EPC STORMWATER REVIEW COMMENTS
IN ORANGE BOXES WITH BLACK TEXT

GRADING AND EROSION CONTROL PLAN

JUDGE ORR ROAD RV PARK AND STORAGE
EL PASO COUNTY, COLORADO

PROJECT NAME:		JUDGE ORR RV PARK	
SHEET TITLE:		POND AS-BUILTS	
CDS PROJ. NO.			
OTHER PROJ. NO.			
SHEET NO:		AS-BUILTS	
REVISIONS:		AS-BUILTS	
NO.		DATE:	
BY		DESIGNED CDS	
		DRAWN CDS	
		CHECKED CDS	
		DATE	
		06/17/2026

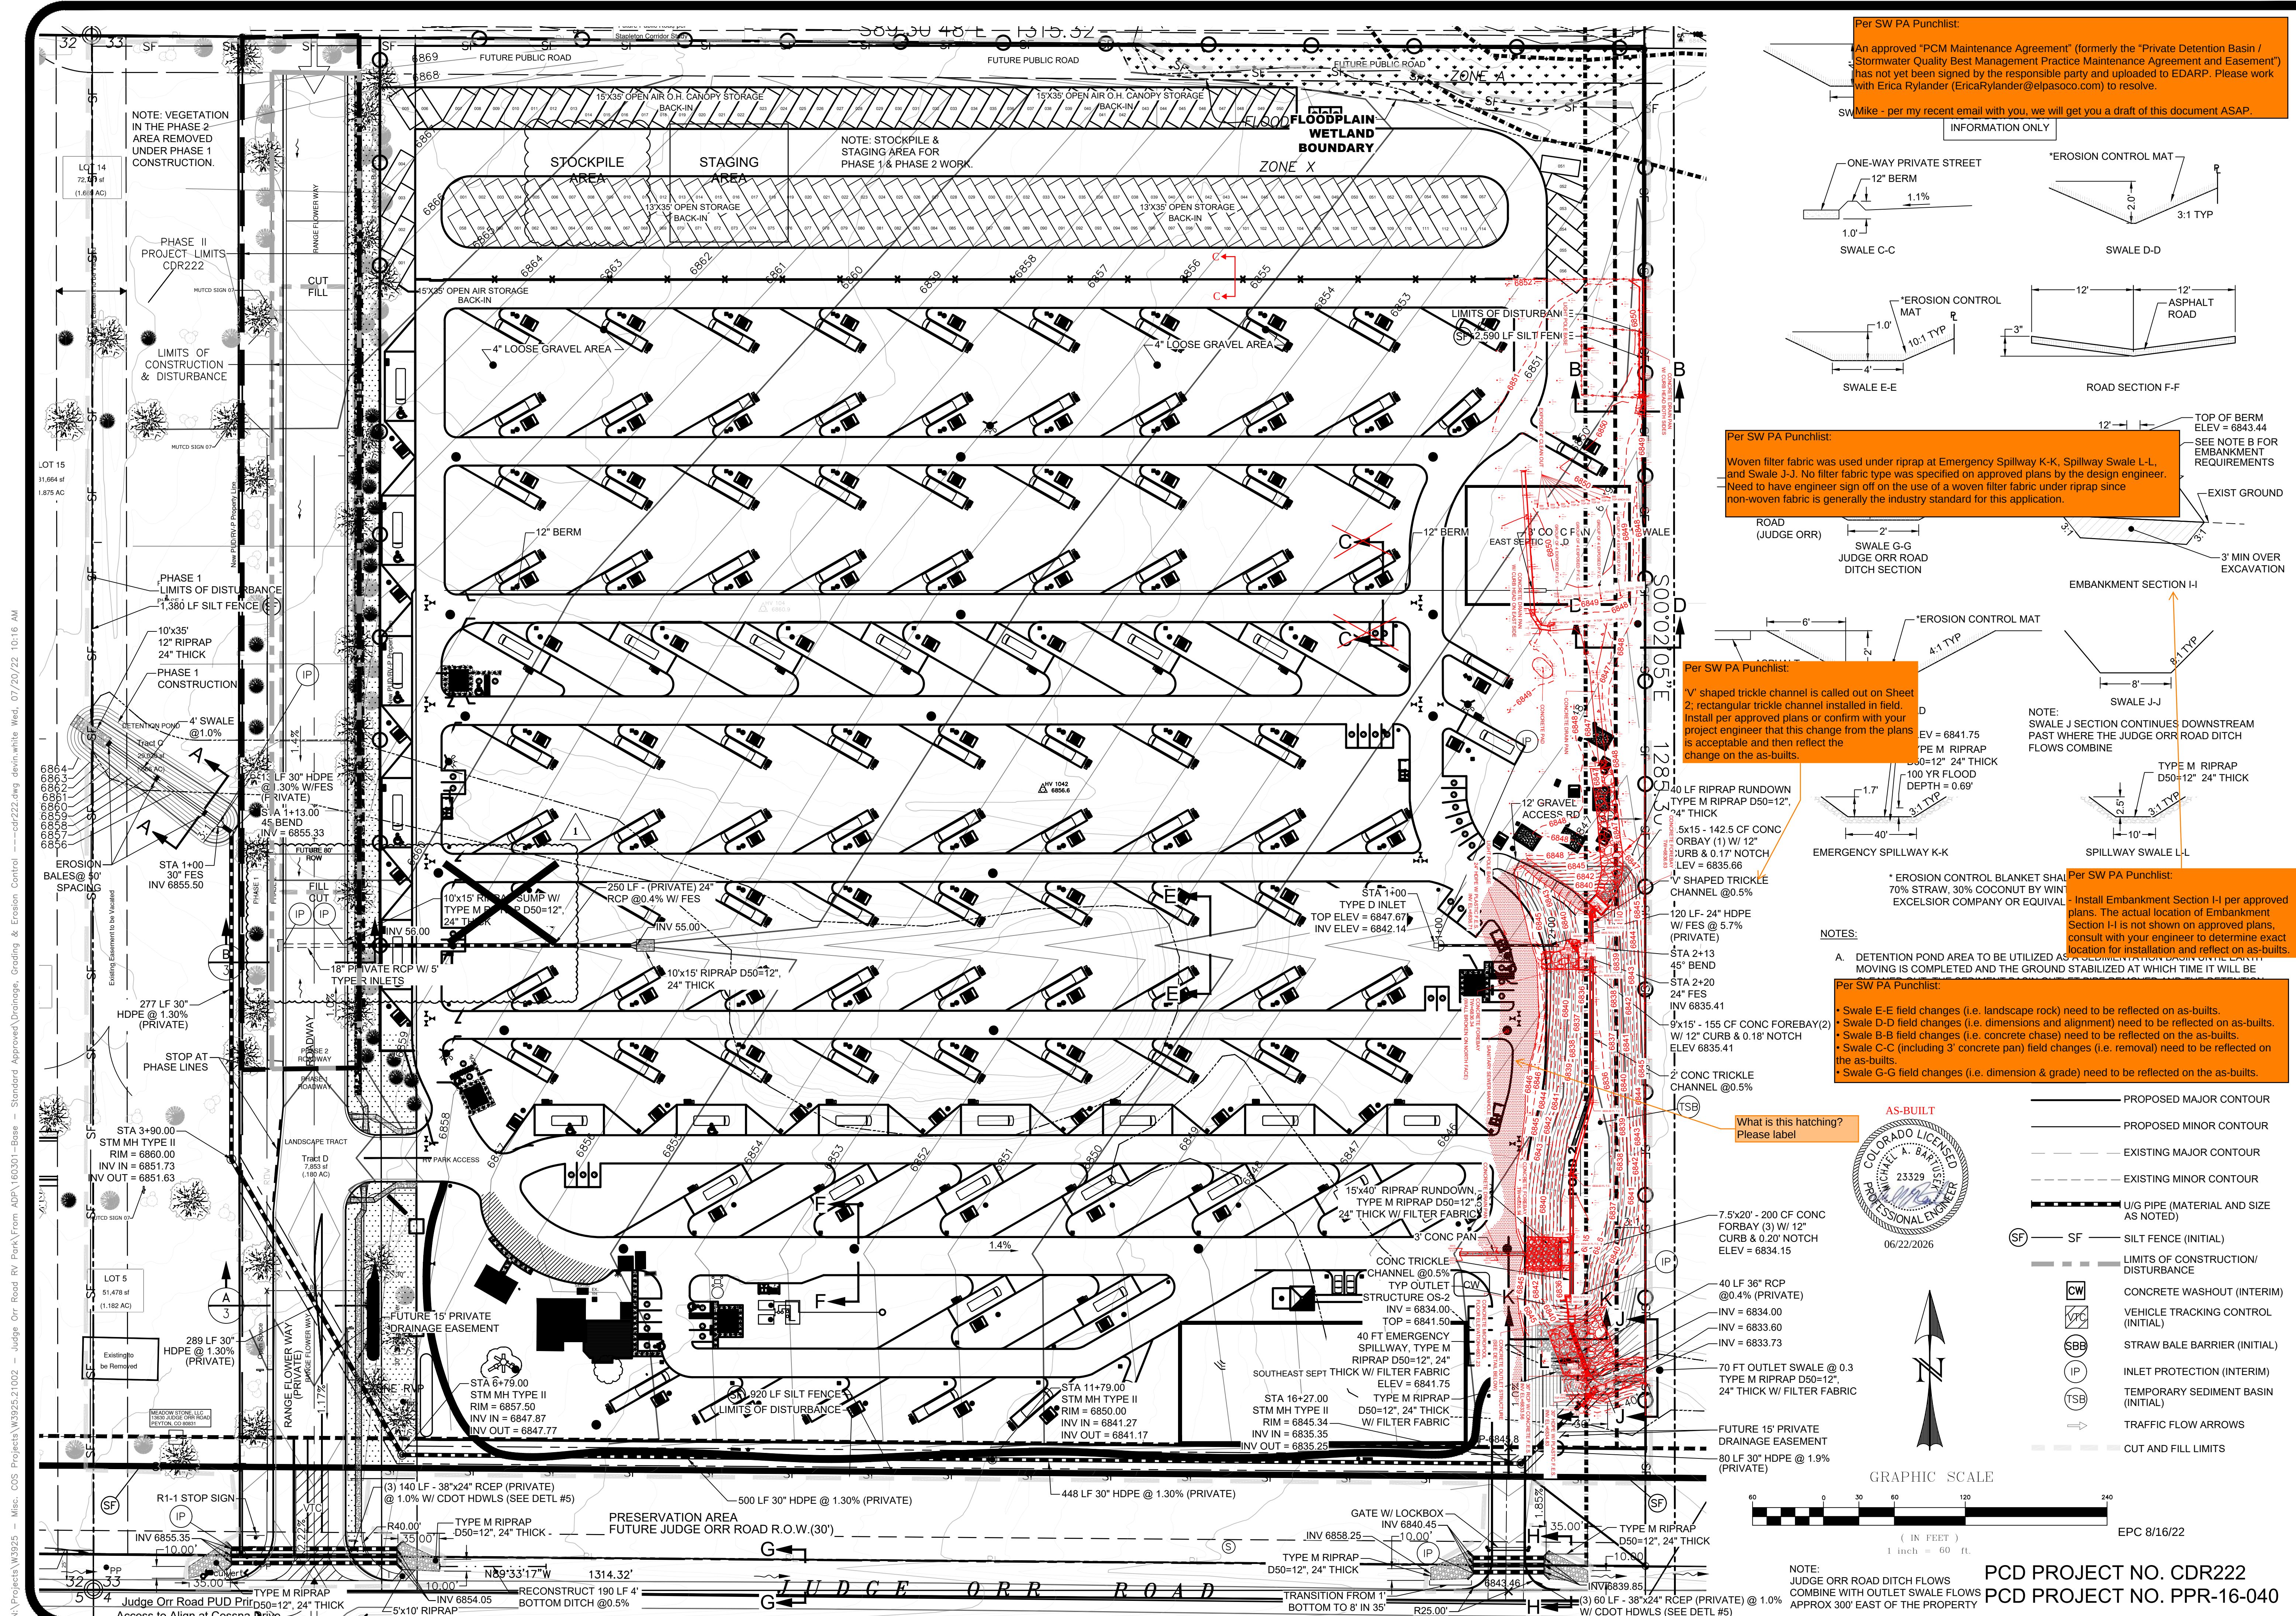
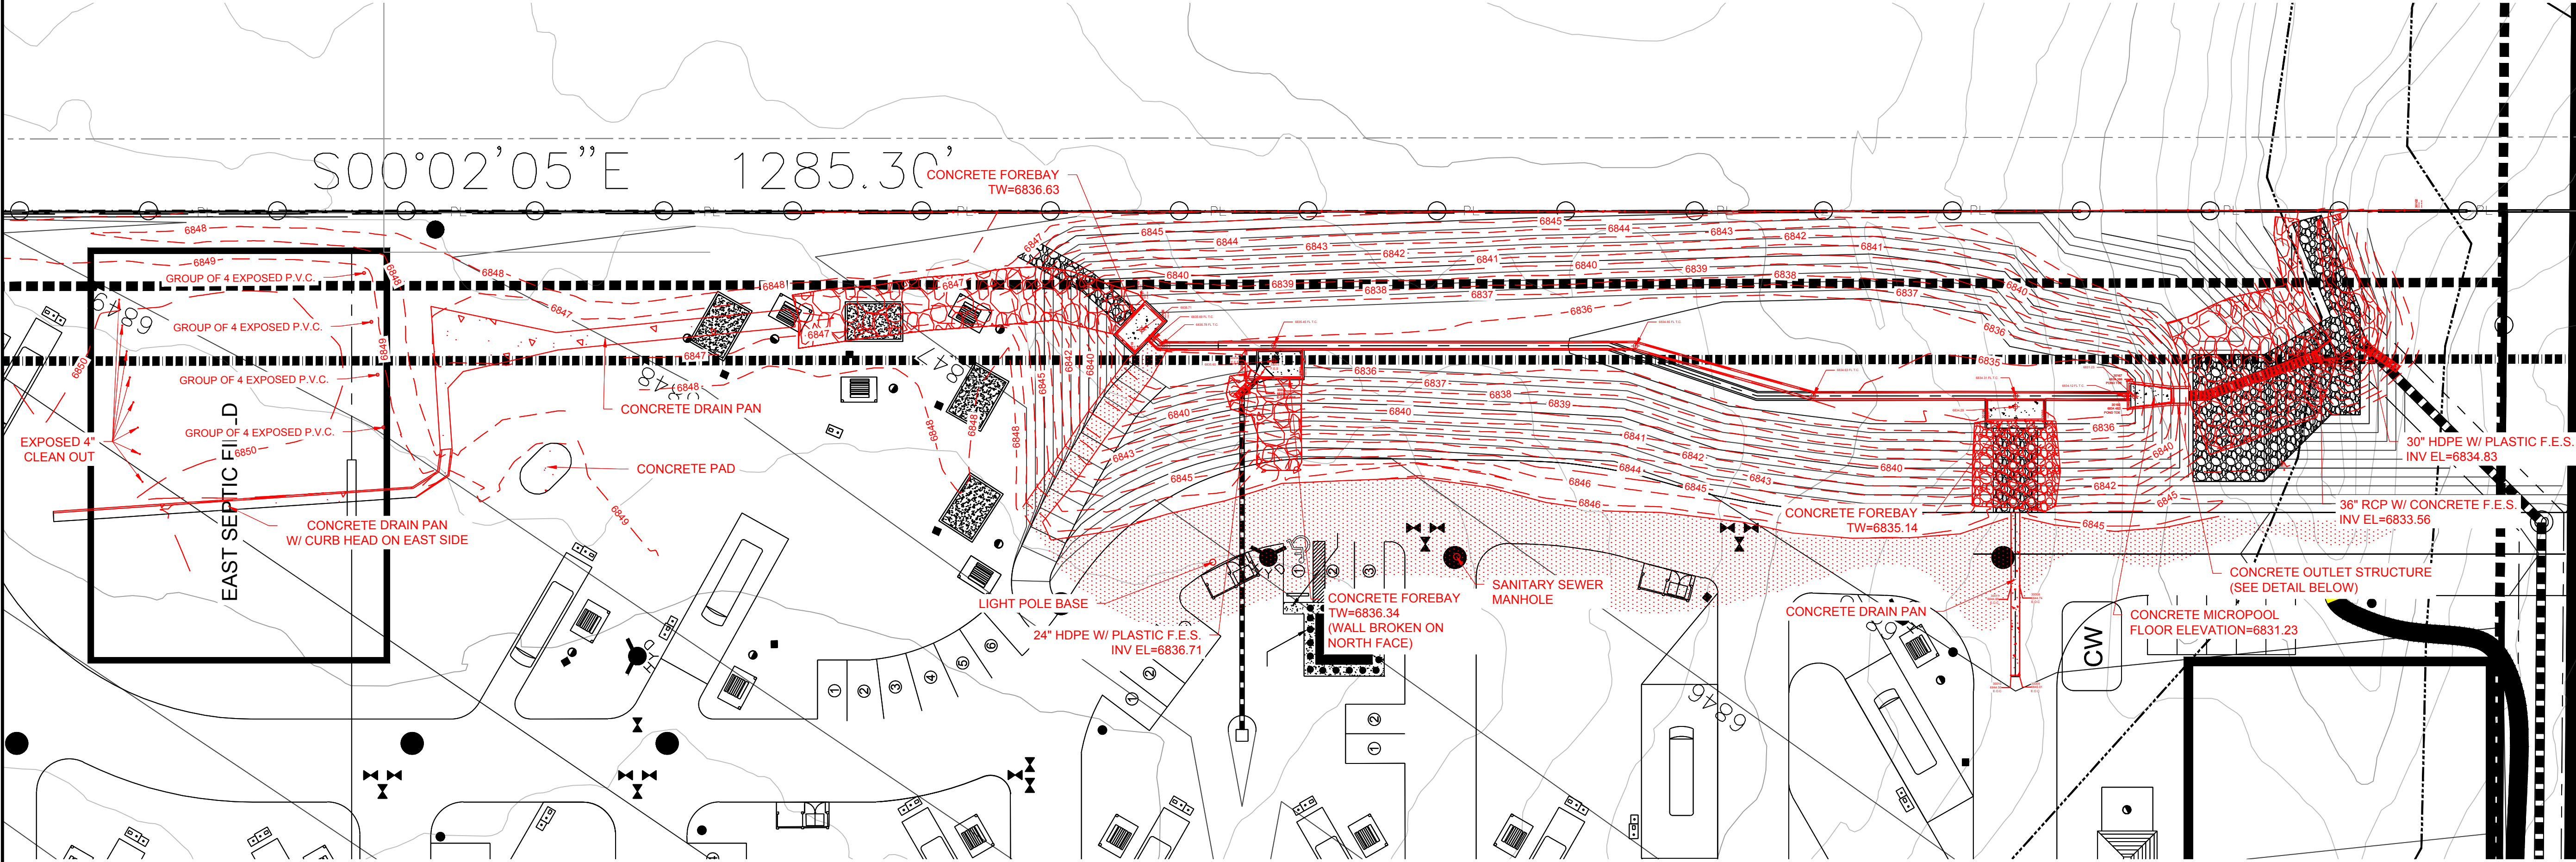
I plan to go to this site in the next couple of weeks to confirm a lot of the items shown in red on here. So I may have additional comments after the site visit. But don't let that delay any revisions and re-submittal of these docs.

Since the last punchlist is >1yr old, we should probably just schedule another walk to generate a new punchlist. It would be great if EPC, you, and Teddy can all be there.

CONCRETE FOREBAY DETAIL (3)
NOT TO SCALE

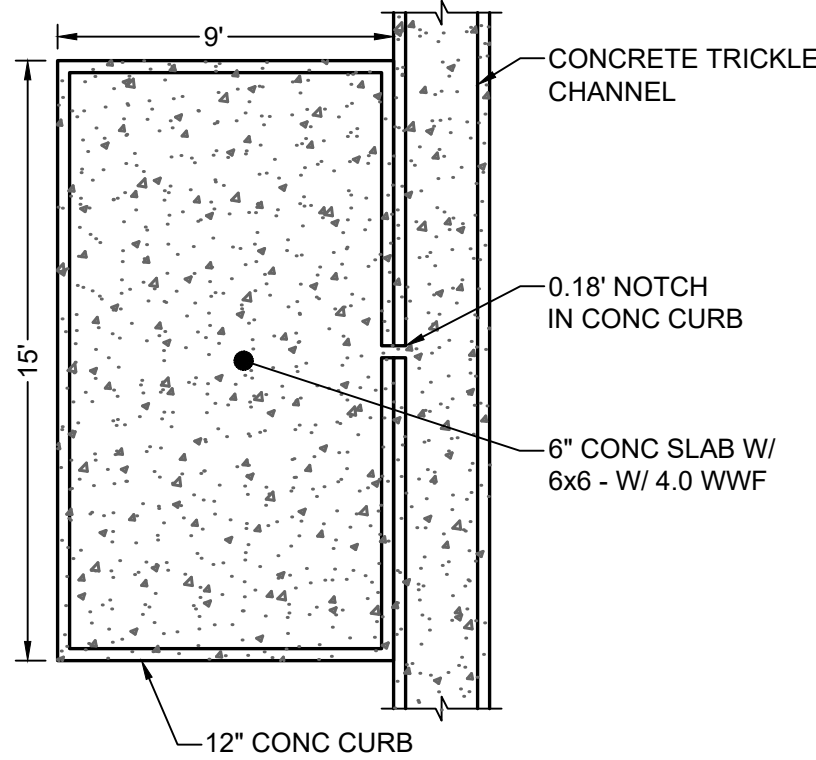
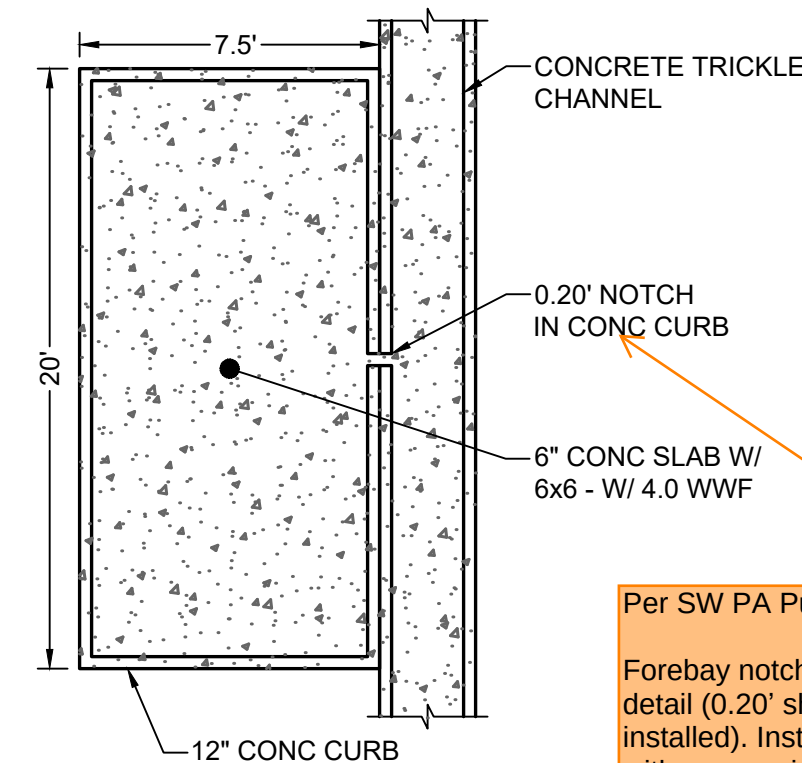
Per SW PA Punchlist:

Forebay notch at Forebay 3 is larger than detail (0.20' shown on drawings; 0.25' as installed). Install per approved plans or confirm with your project engineer that this change from the plans is acceptable and then reflect the change on the as-builts.
